City of Biddeford

Planning Board

December 02, 2020 6:00 PM Zoom: Dec 2, 2020 06:00 PM Eastern Time (US and Canada)

6.A. 2020.25 Conditional Use Permit for a Medical Marijuana Manufacturing (Growing) Facility for Stoner & Company at 419 Hill Street (Tax Map 74, Lot 9) in the I-2 Zone.

- Current flood light locations
- Planned FDC Location

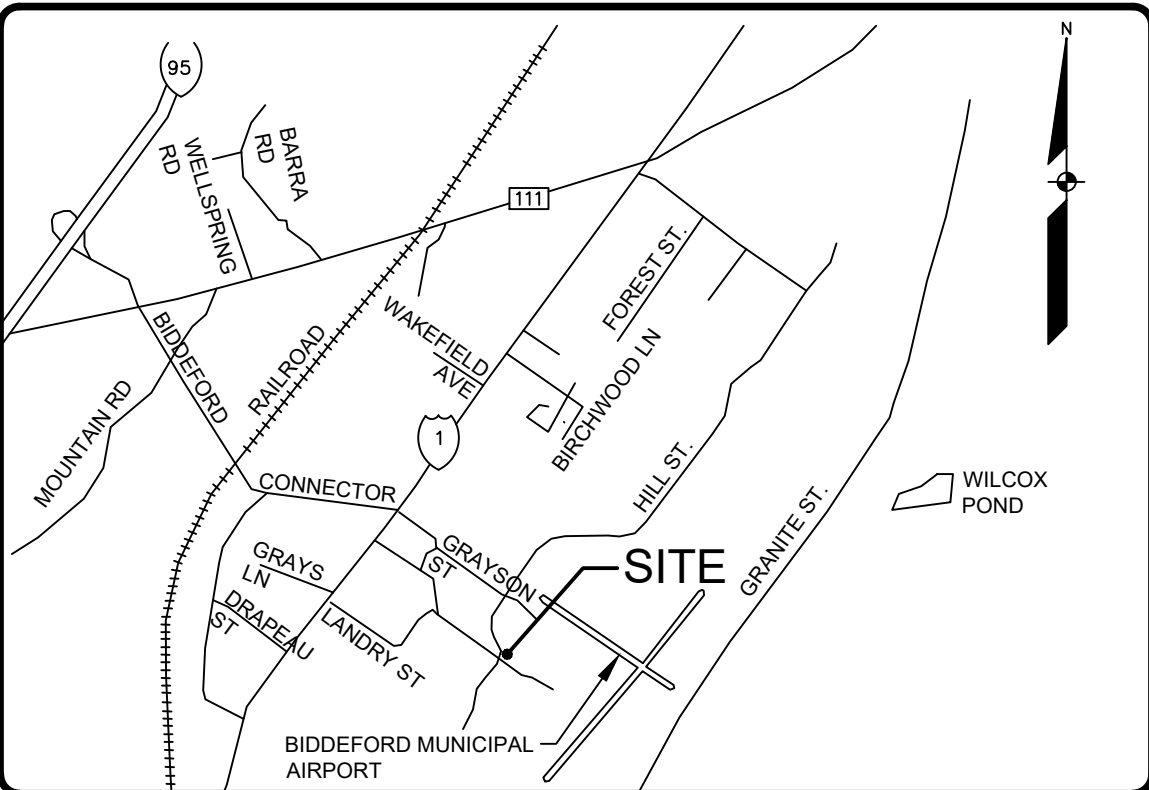
The Fire Department was asked to review the project proposal and their only comment was related to the location of the FDC for the sprinkler system, which they asked to be on the Landry Street side of the building, which they have done.
